**DEVELOPMENT AGREEMENT (REF: HRM CASE #21099)
APPLICATION FOR A SUBSTANTIVE AMENDMENT
MULTI-UNIT RESIDENTIAL BUILDING, FOURTH STREET, BEDFORD**

December 13, 2019

Re: Bedford Highway & Fourth Traffic Impact Statement Addendum

Exhibit 1 – Bedford Highway and Fourth Street Site Plan

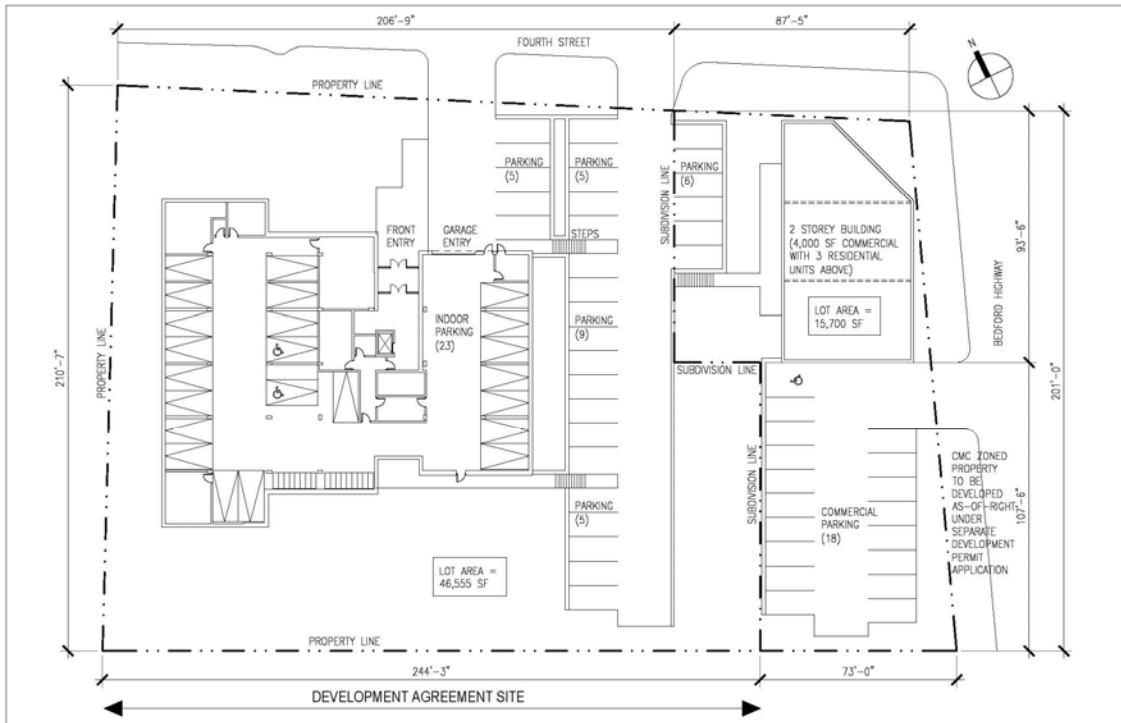
The developer has revised their plans for the site and Phase 1 will now have 4,000 sqft of Commercial/Retail space on the Ground Level accessed from Bedford Highway with 3 apartments behind that will be accessed from Phase 2 once that is completed. Phase 2 will have 27 residential apartments and no townhouses. Refer to Exhibit 1.

DRAWING TITLE:
**SCHEDULE B:
 SITE PLAN**

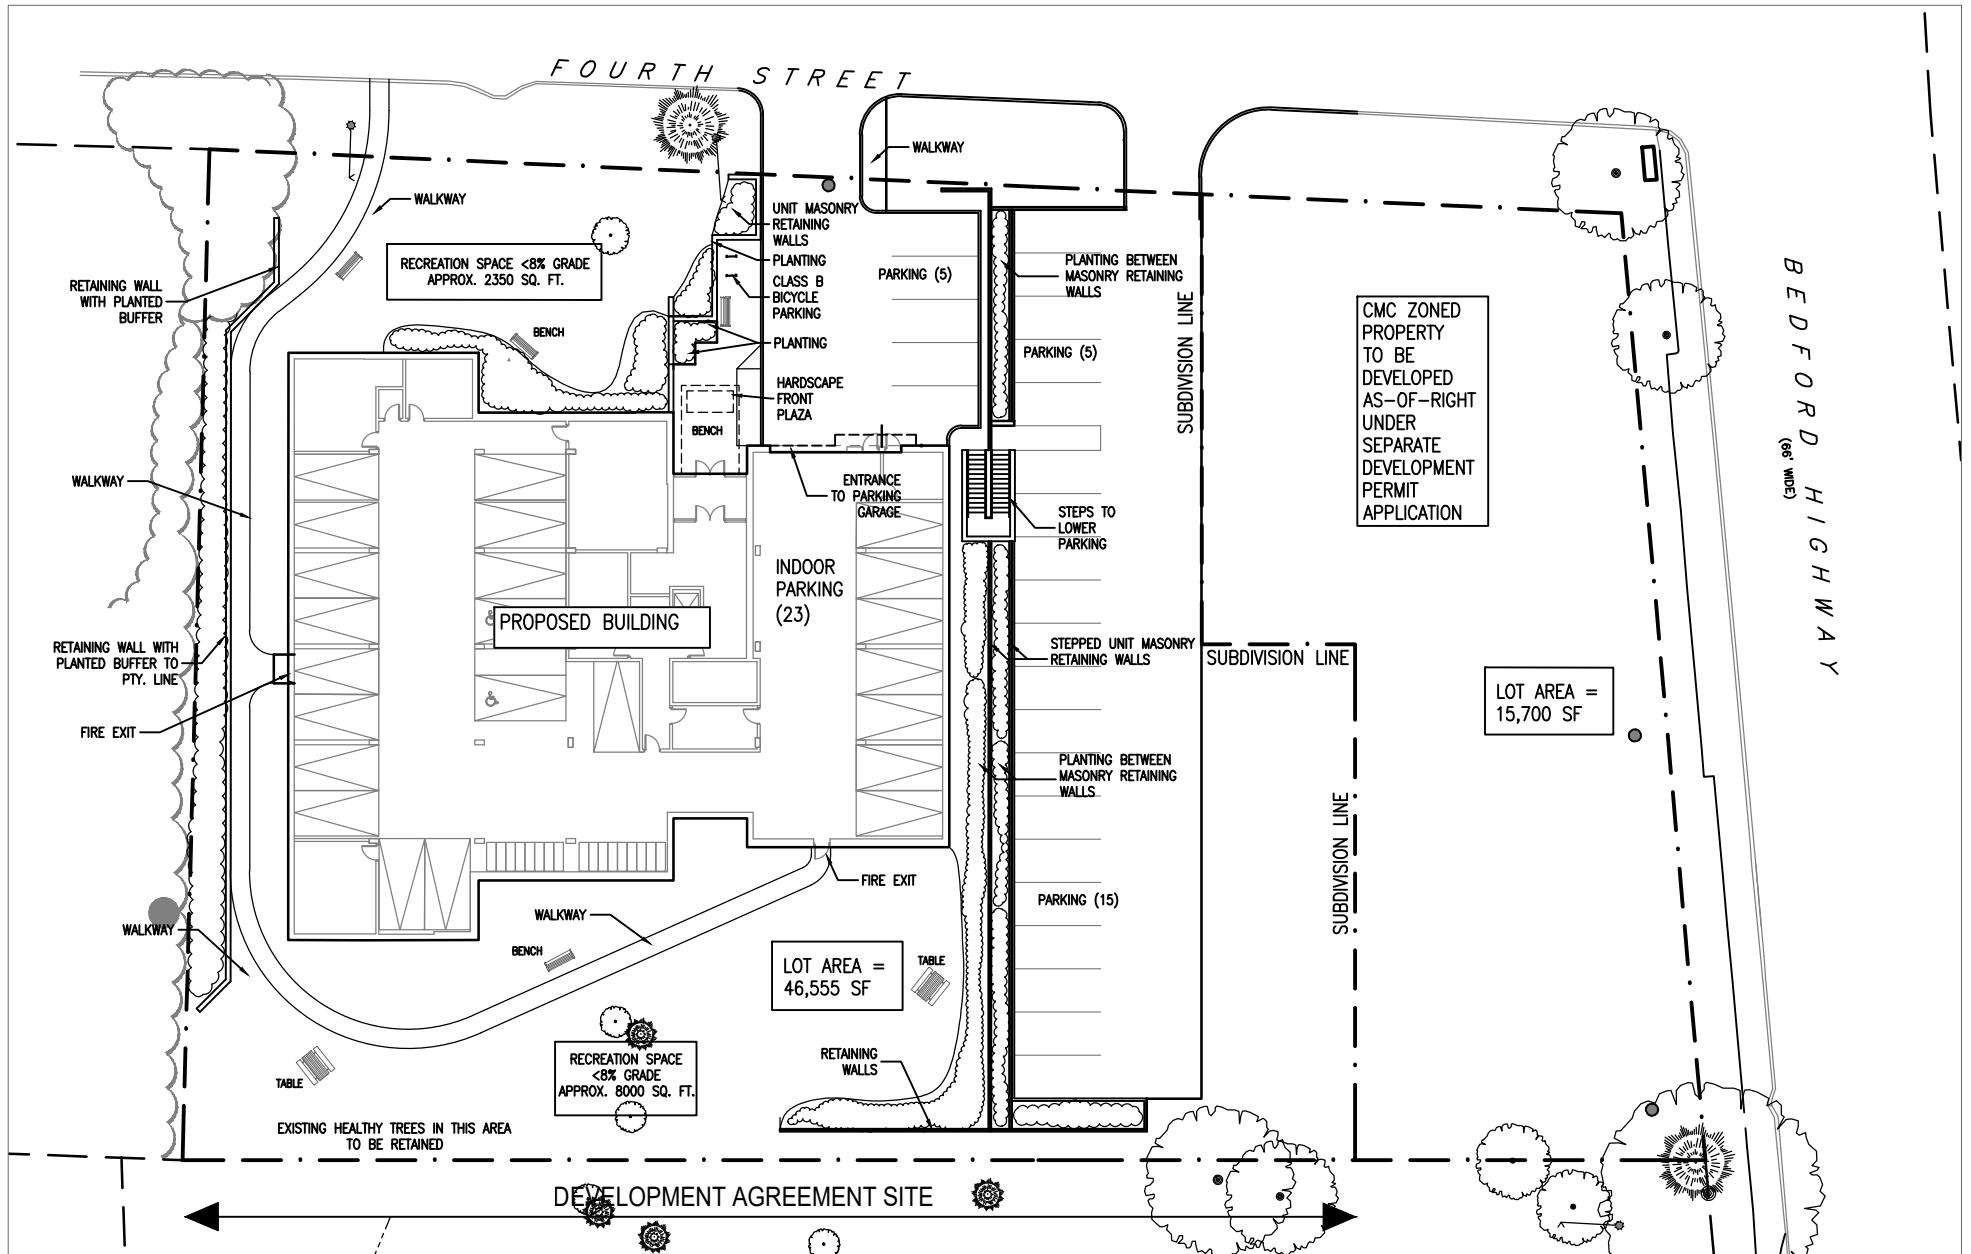
As per above, a minimum lot area of 46,500 sq.ft. is required. Accordingly, the attached Schedule B: Site Plan illustrates an amendment to the line of subdivision in order to increase the lot area. As shown, the amended lot area is 46,555 sq.ft. This consequently reduced the area of the adjoining lot located along Bedford Highway, which is under the same ownership.

The proposed design, as illustrated on the attached Schedule B: Site Plan, provides an additional 20 outdoor parking spaces for a total of 25 outdoor spaces. In combination with the indoor parking garage, this provides a total of 48 spaces, which is 7 more than the minimum requirement.

Reference: Schedule B: Site Plan
Proposed Amendment: An amended Schedule B is enclosed. For information only, a suggested outline is provided for the adjacent CMC zoned lot, which will be subject to a separate Development Permit application.
Description/Rationale: The site plan is amended to accommodate an increase in dwelling units from 18 to 27. This requires an increase in outdoor parking as well as an increase to the lot area.
The building size, shape, layout and location remain unchanged. As well, the driveway to the parking garage entry and its associated 5 parking spaces and front entry area remain unchanged.
For parking, an additional outdoor parking area is created along the eastern side of the lot between the building and line of subdivision. Due to the slope of the land, separate access is required to this parking area from Fourth Street. From this parking area, a set of steps are provided to allow access to the front entry.
